FW: City of Albuquerque

Sent: Thursday, April 28, 2016 9:30 AM To: 'patrick.hogan@kimley-horn.com'
Subject: RE: City of Albuquerque

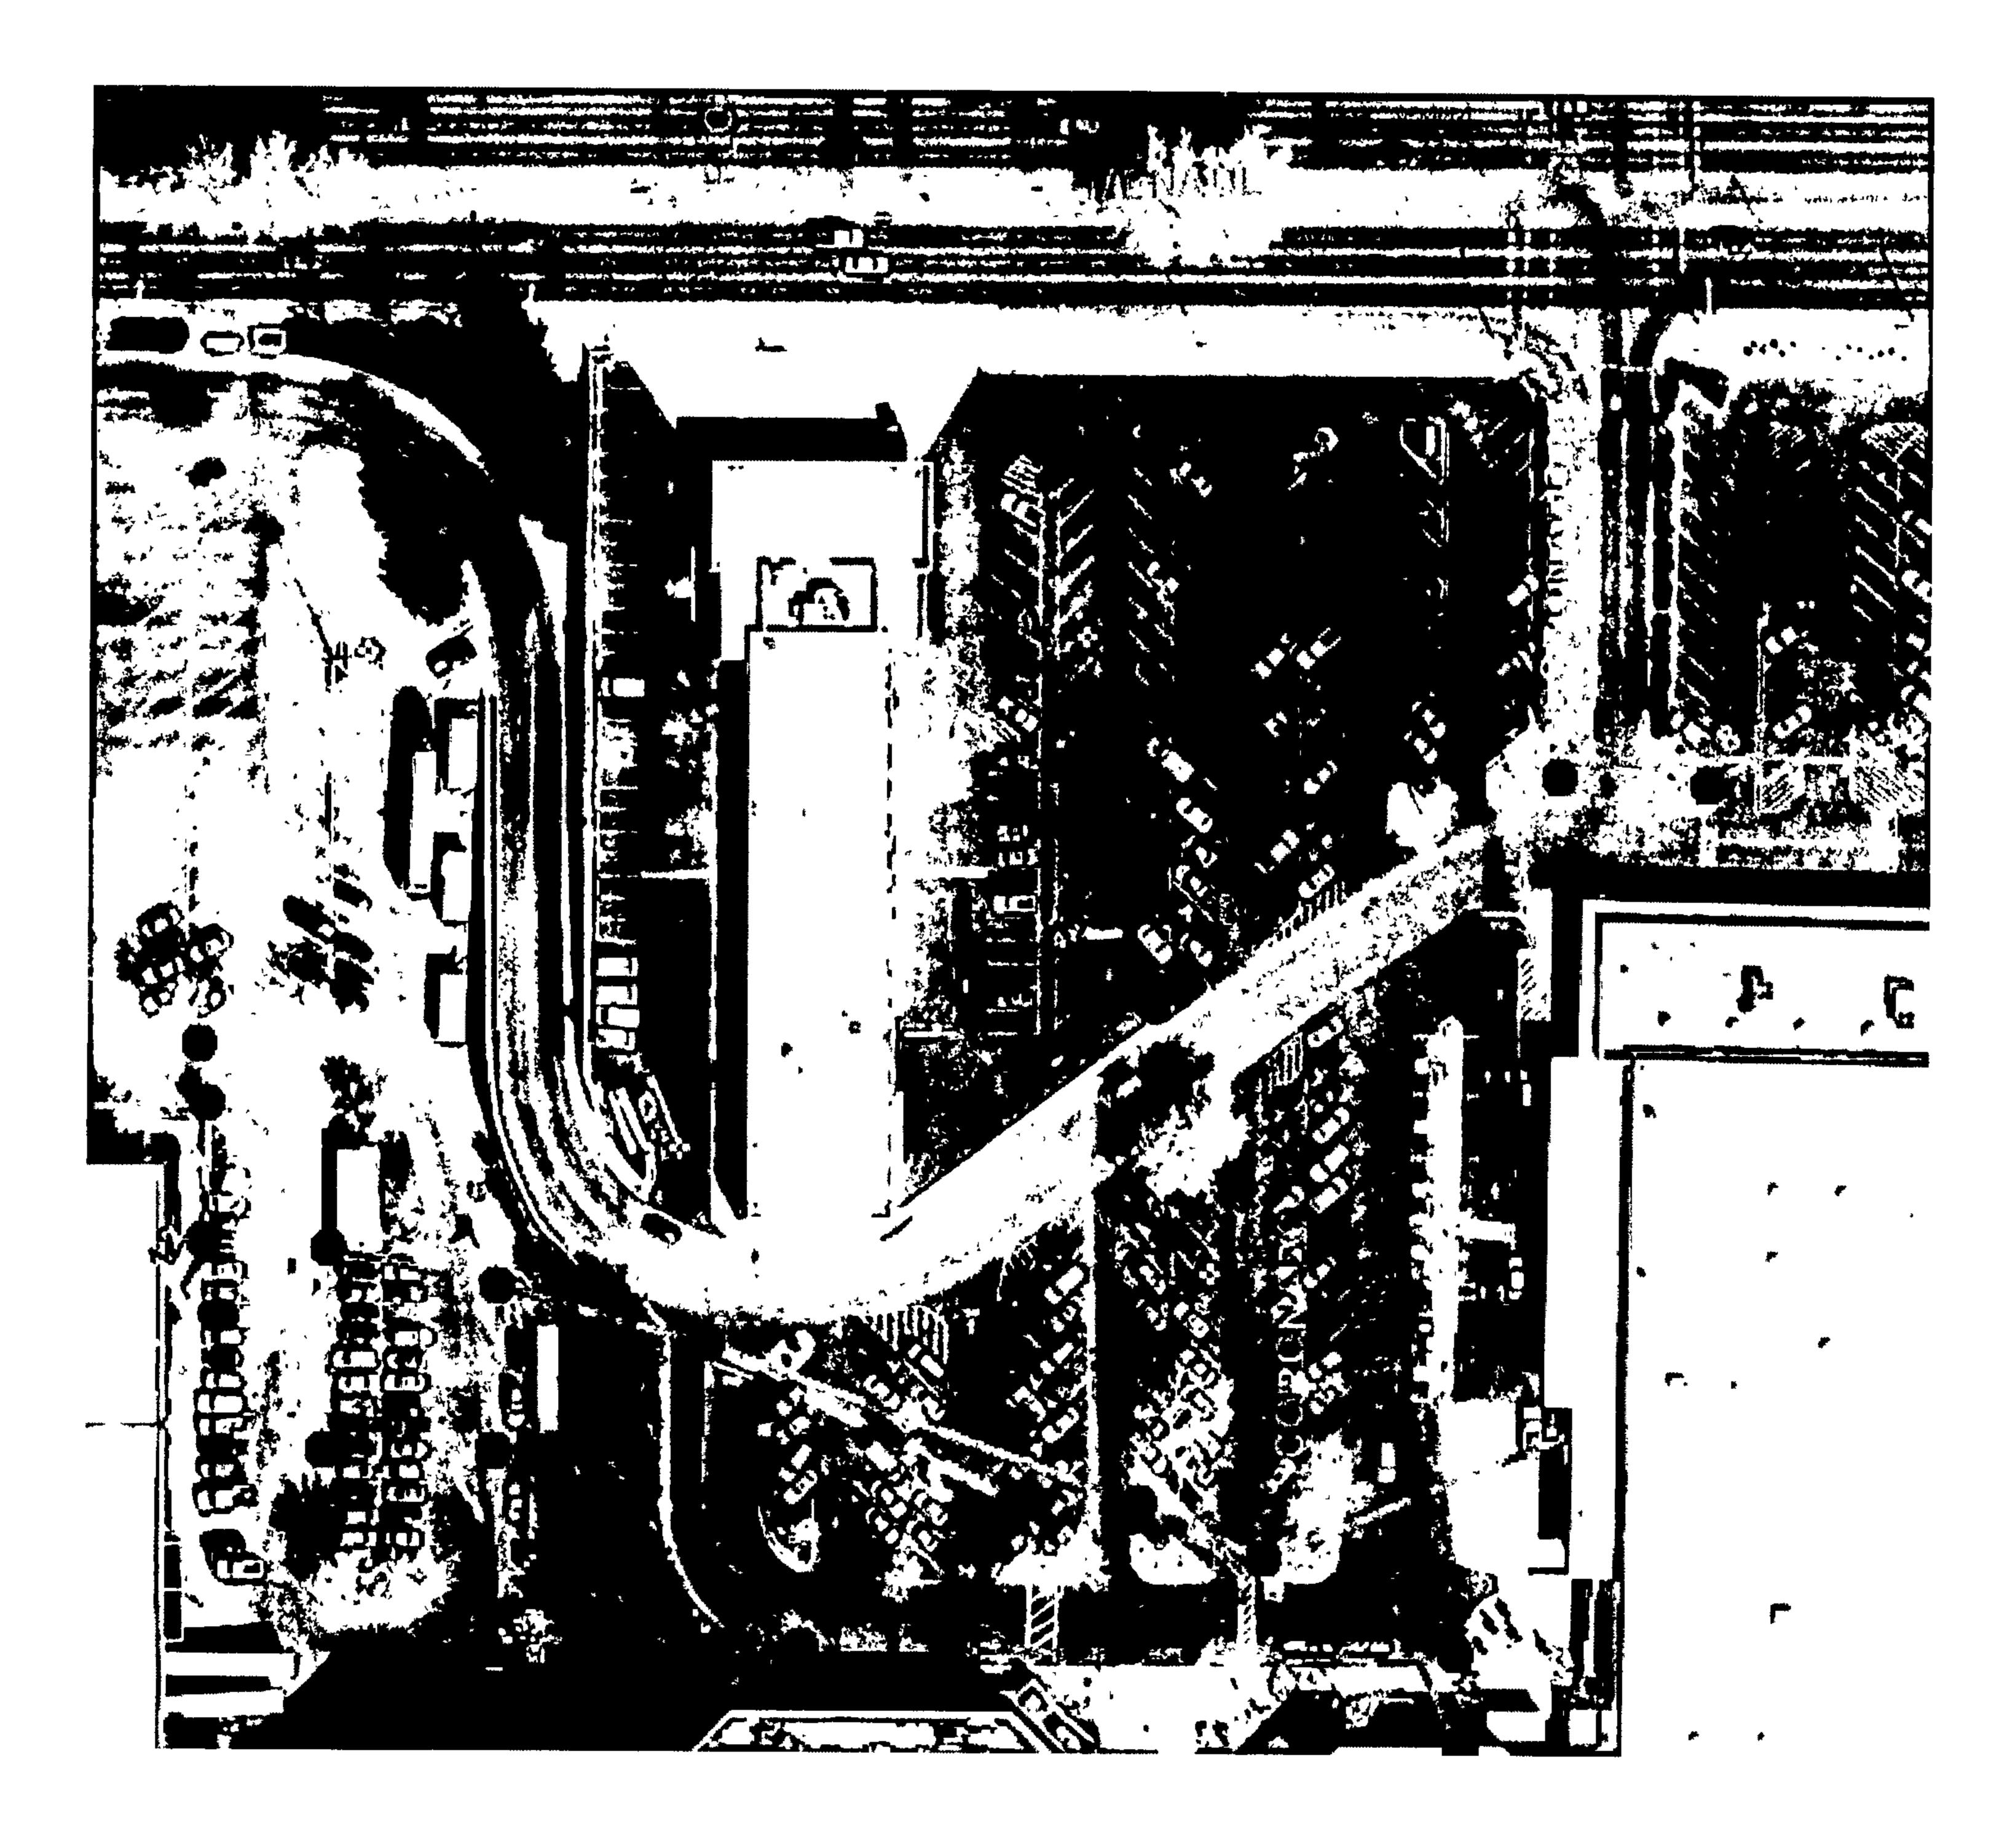
- Adjust the grades so that more flow from the parking area can be more directly conveyed to the depressed landscaping within the parking islands.
- Provide a Low point spot elevation and/or contours on the shallow ponds in the parking islands
- In the Narrative, explain that is redevelopment project and as such, leeway should be given in regards to capture of first flush
- Per our discussion, roof flows are intended to go directly into a private storm drain. Show the private storm drain. I would be OK with roof flows bypassing the first flush ponds if there is more effort to capture most of the parking area.
- Show the volume, either in a report on with all other calcs, that is captured by the islands and compare to what is required.
- Show the intended outfall. Is it the inlet at the NE corner of Sears?
- Show the Public Storm Drain (see screen shot)
